A8 Display Board Assembly 400074-20

The A8 Display Board assembly number 400074-20-1 is a direct replacement for the older version 400074-20. There is no need for any kind of alignment. It can be easily installed without any tools.

Fig.1 DF2100 Display Board Assembly 400074-20-1 (A8)

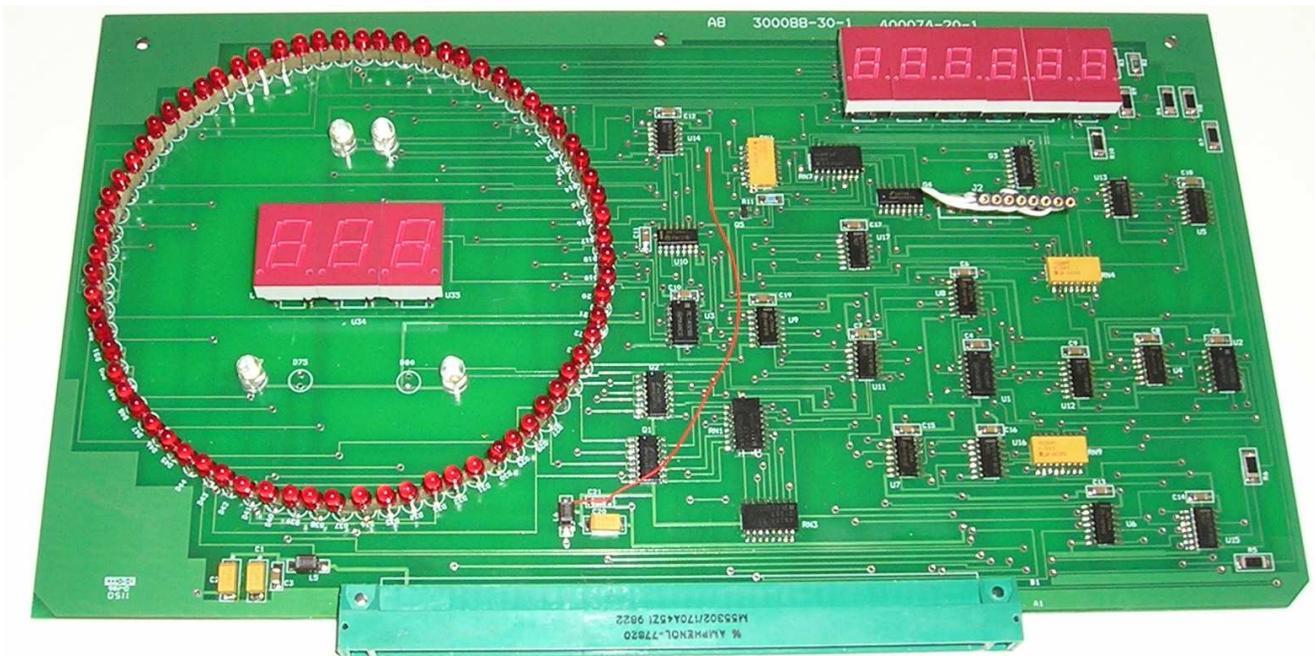
The only difference between the assemblies is that the thru-hole mount components were replaced by the surface mount type.
